USNRC APPLICATION
SUA-1341 License Amendment
Ludeman Project
Converse County, WY

TECHNICAL REPORT
REQUEST FOR ADDITIONAL INFORMATION
RESPONSE PACKAGE

June 2013

Production Only

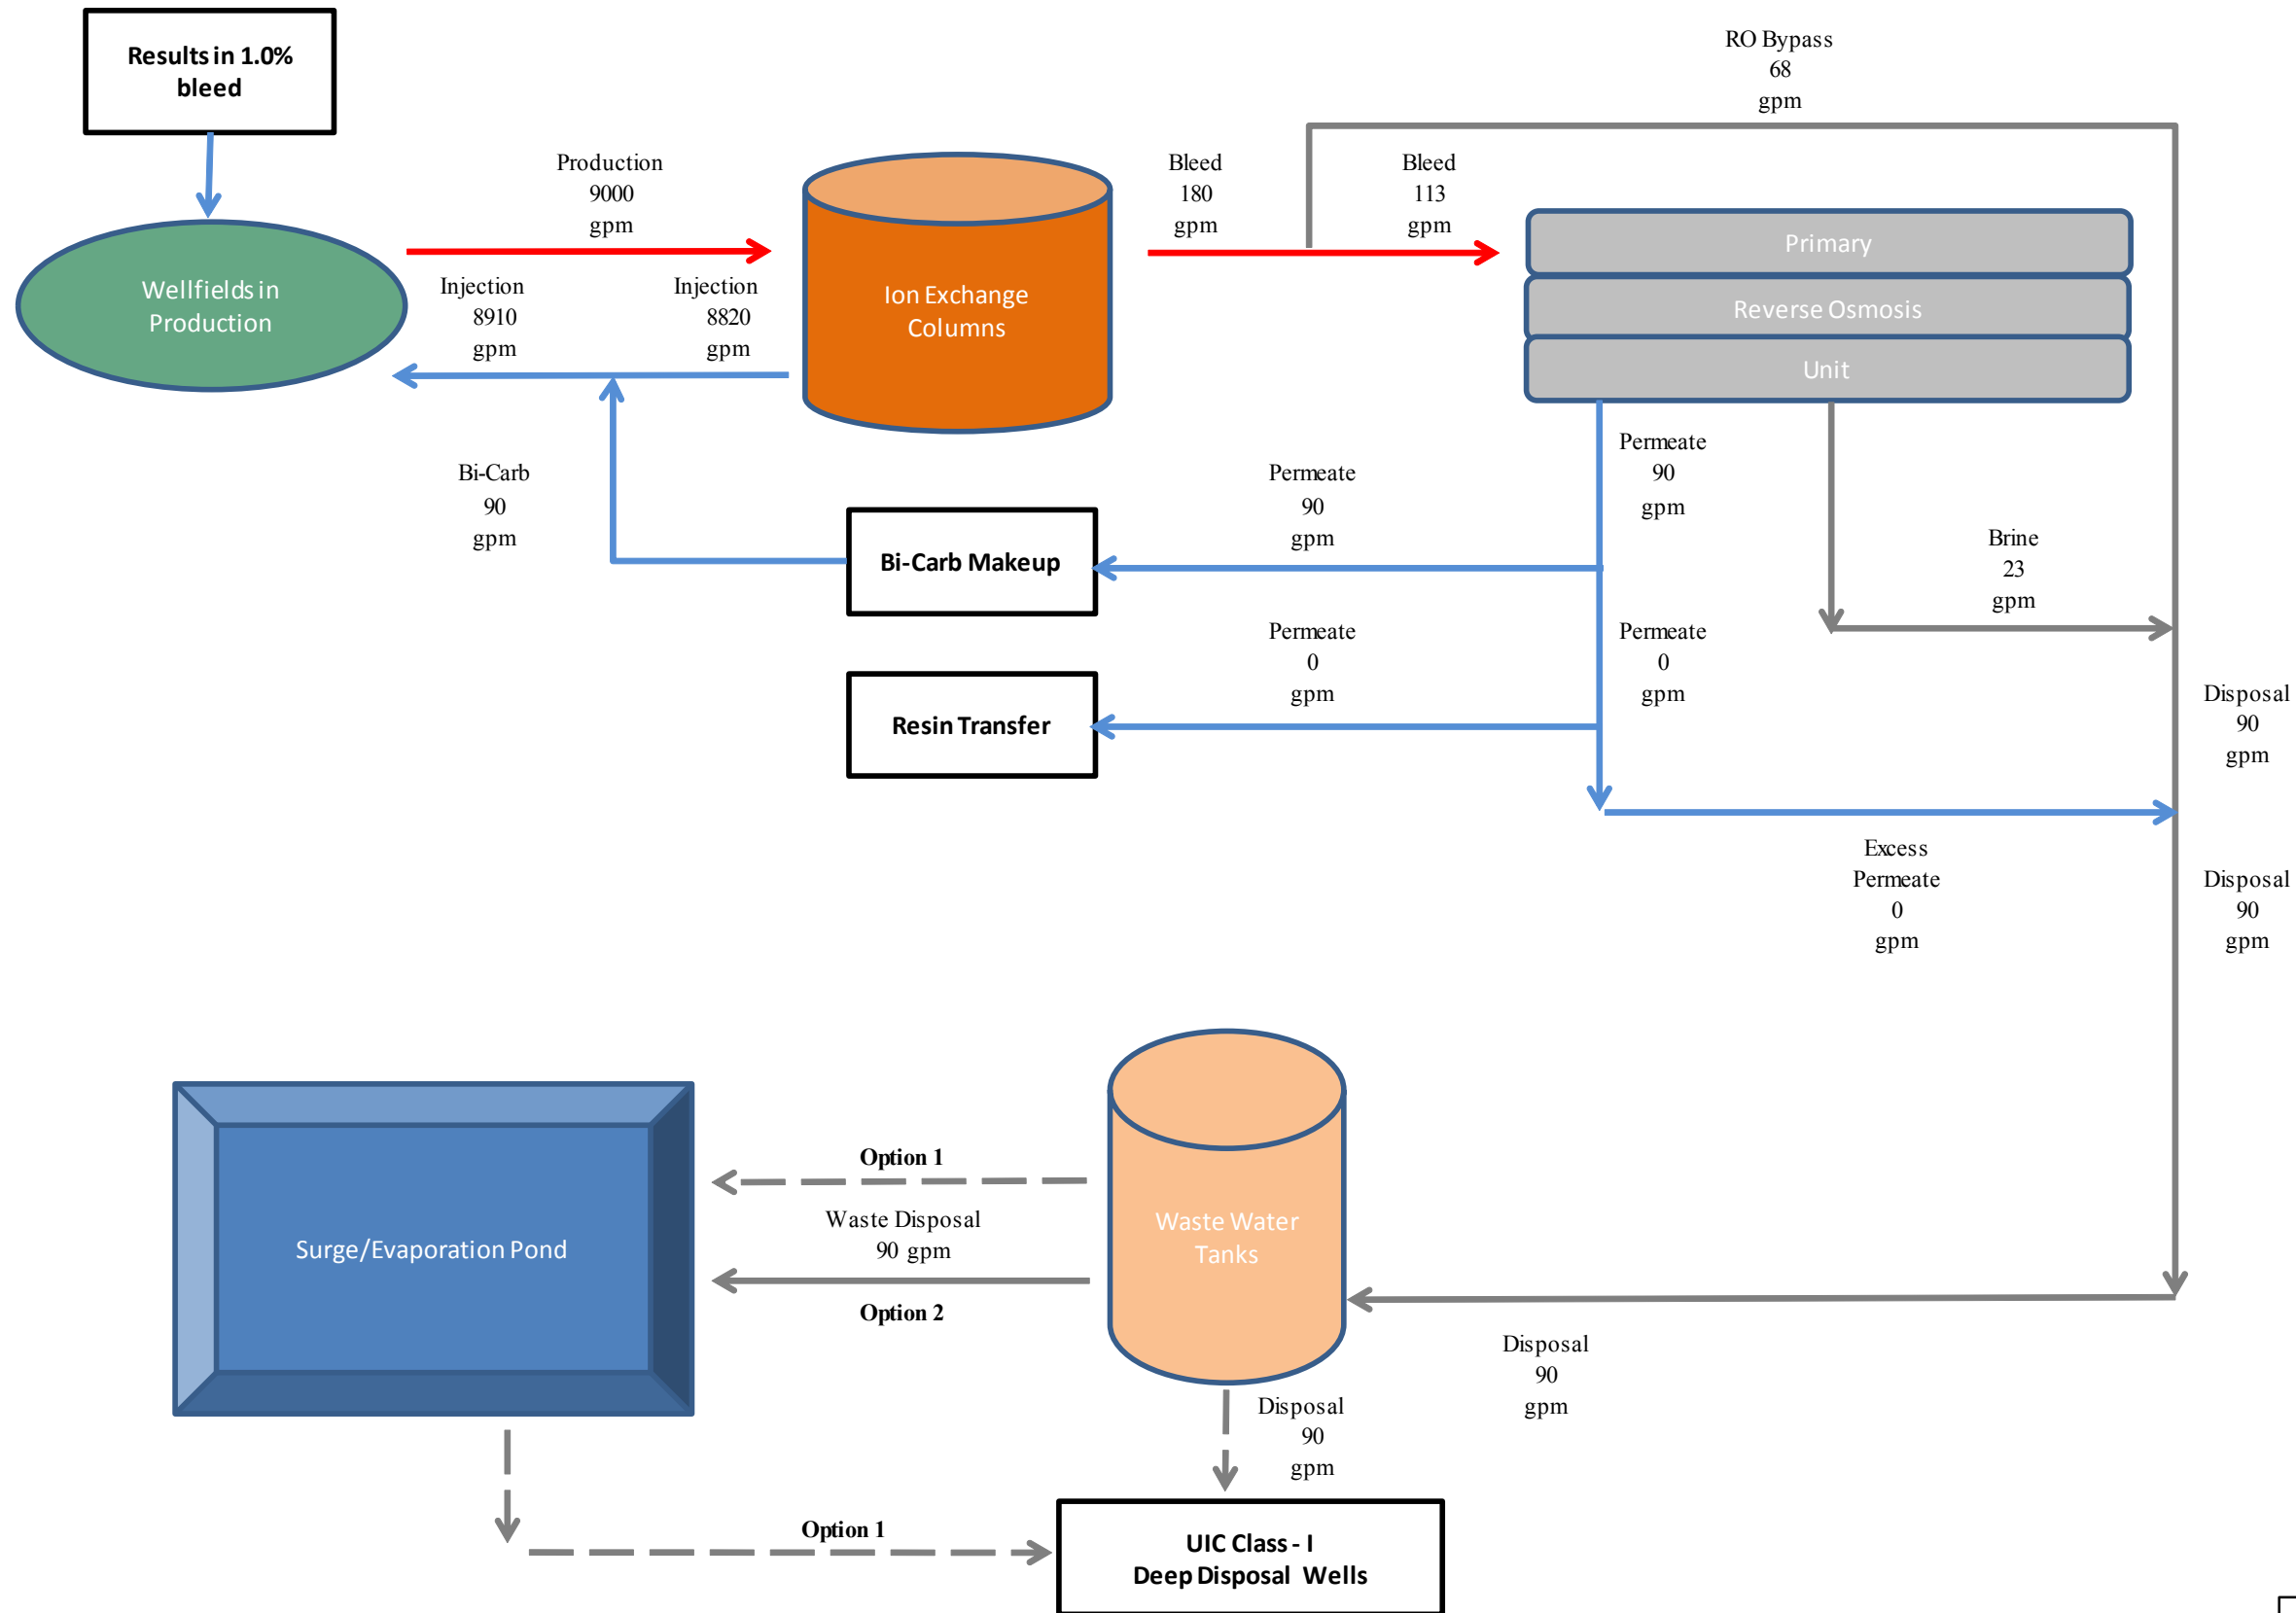
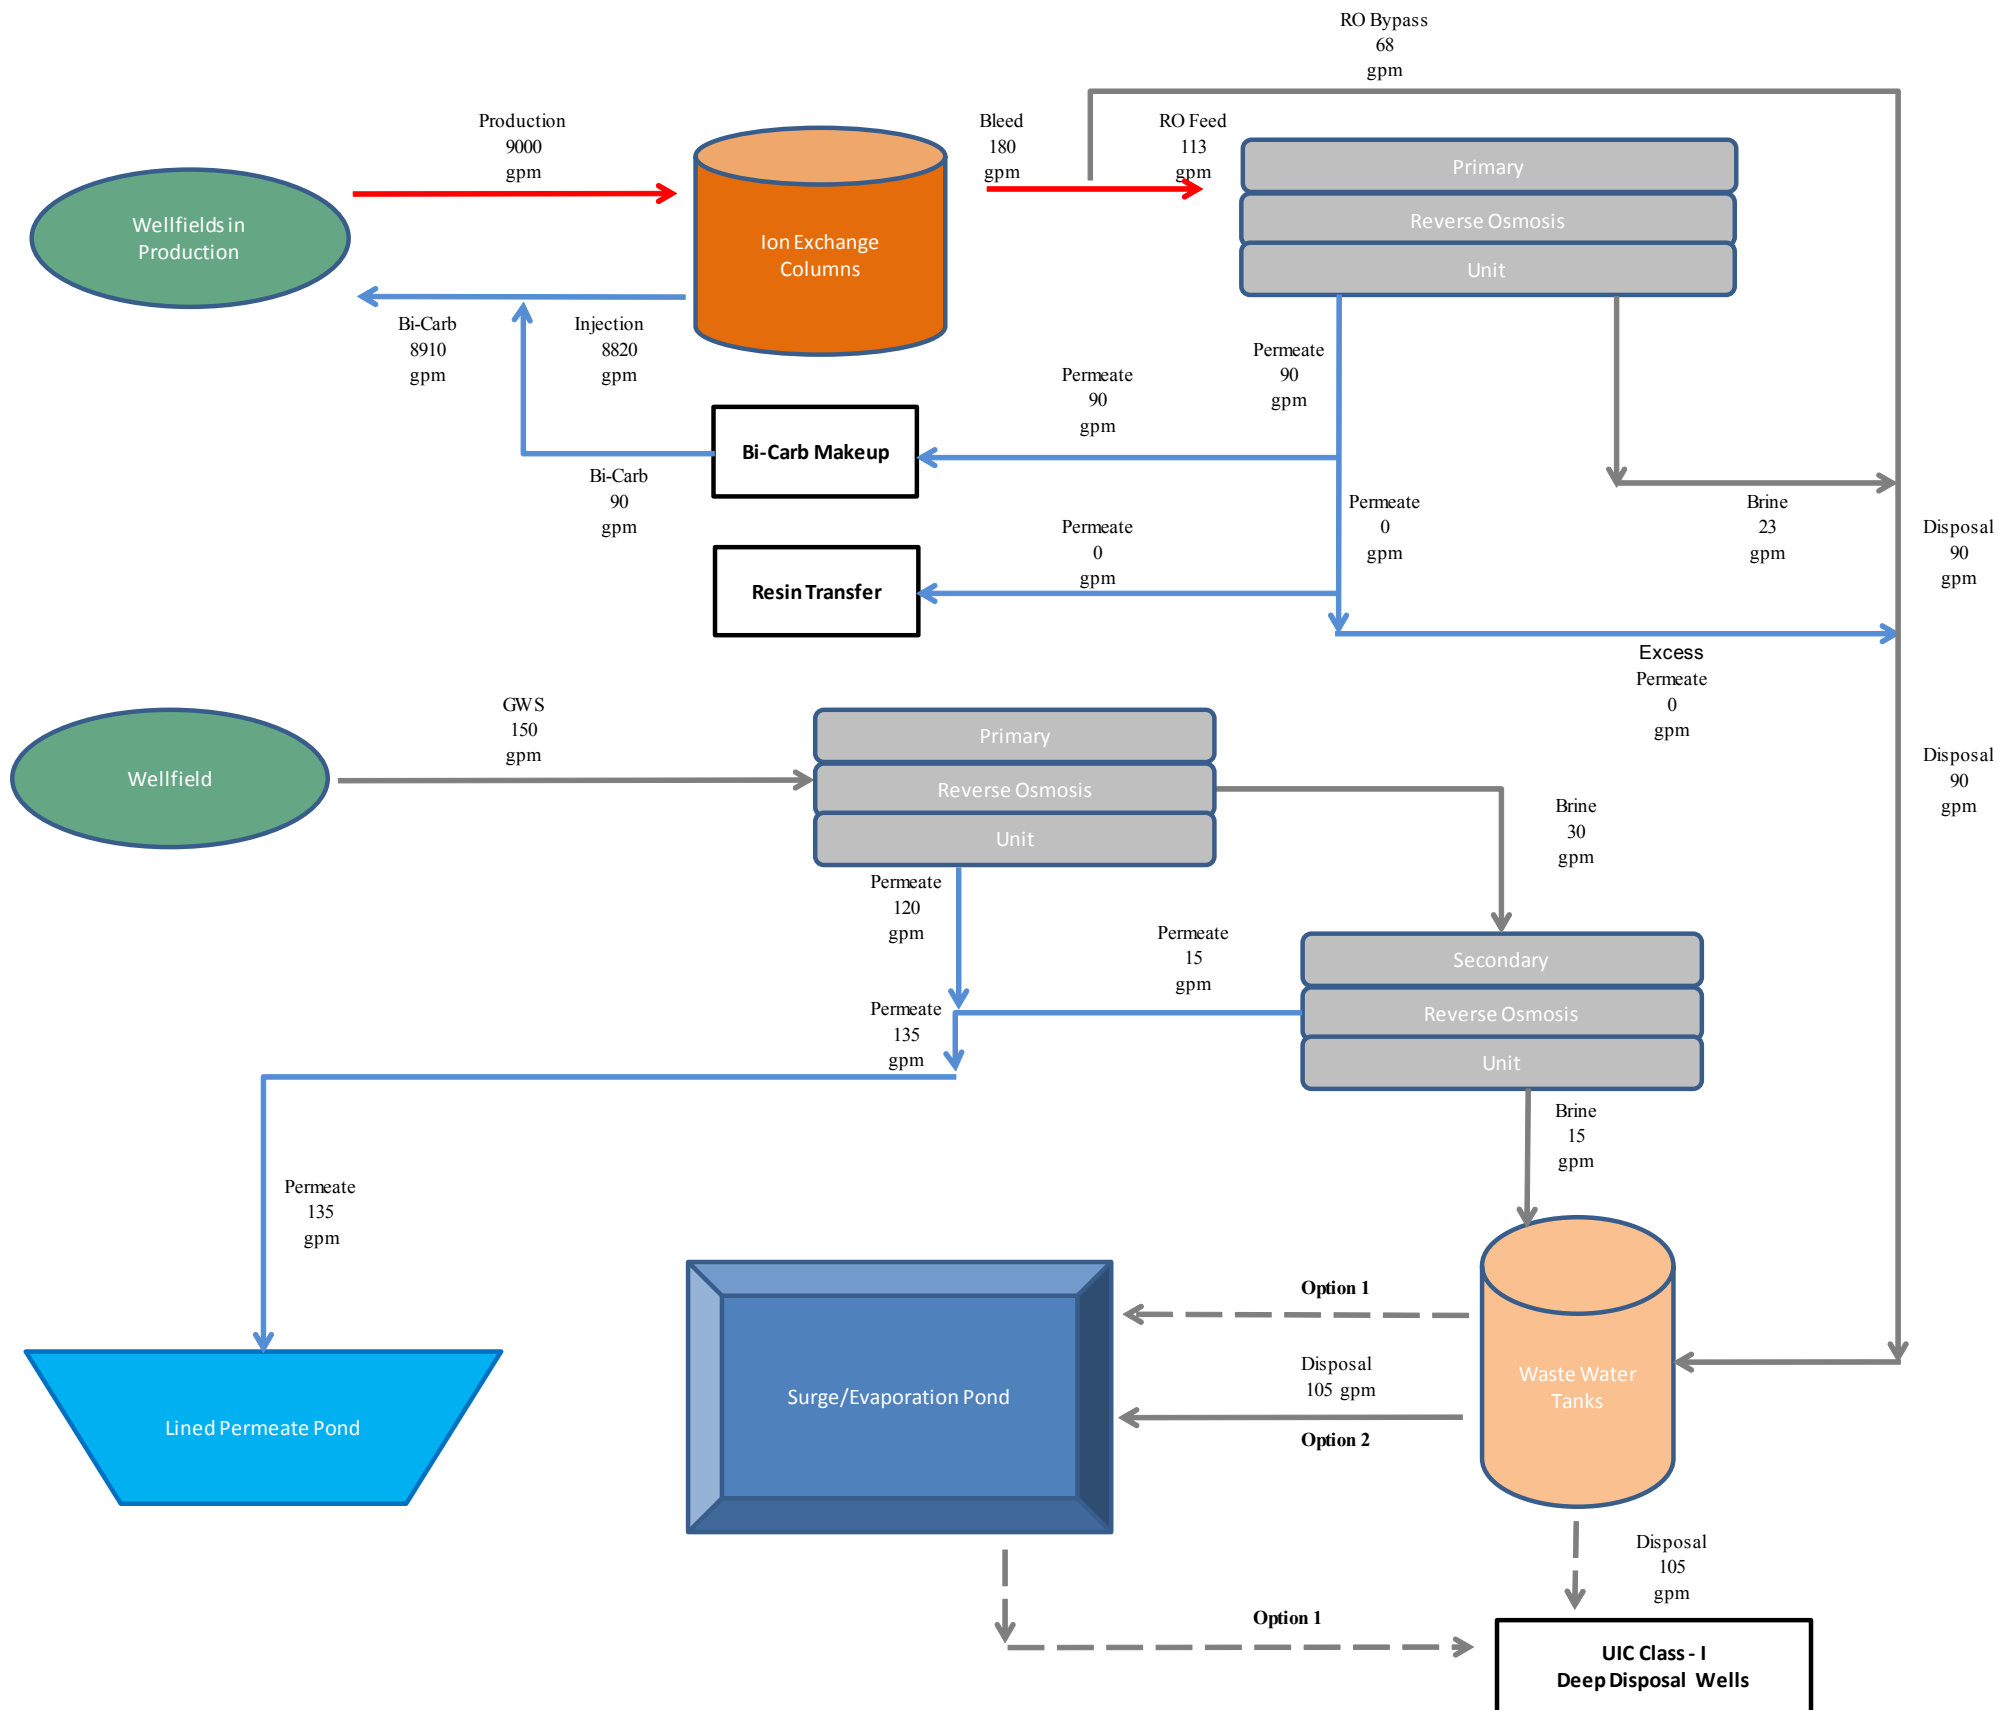
Please provide the water balance for each Project phase at each Satellite facility.

- A. Please modify Figure 3-6 of the TR to include reverse-osmosis treatment of bleed water and the flows of permeate and brine as components of the overall water balance.*
- B. Please address the potential for and volume of excess permeate during the first two years of operation before groundwater restoration begins (shown in Figure 1-4 of the ER) and clarify the proposed disposal method of this waste stream.*

Uranium One has developed new water balance figures and values to both reflect the current water balance flows and provide the NRC quantitative data in support of the environmental impact analysis. The following figures depict the water balance during all phases of the project and have been added to TR Section 4:
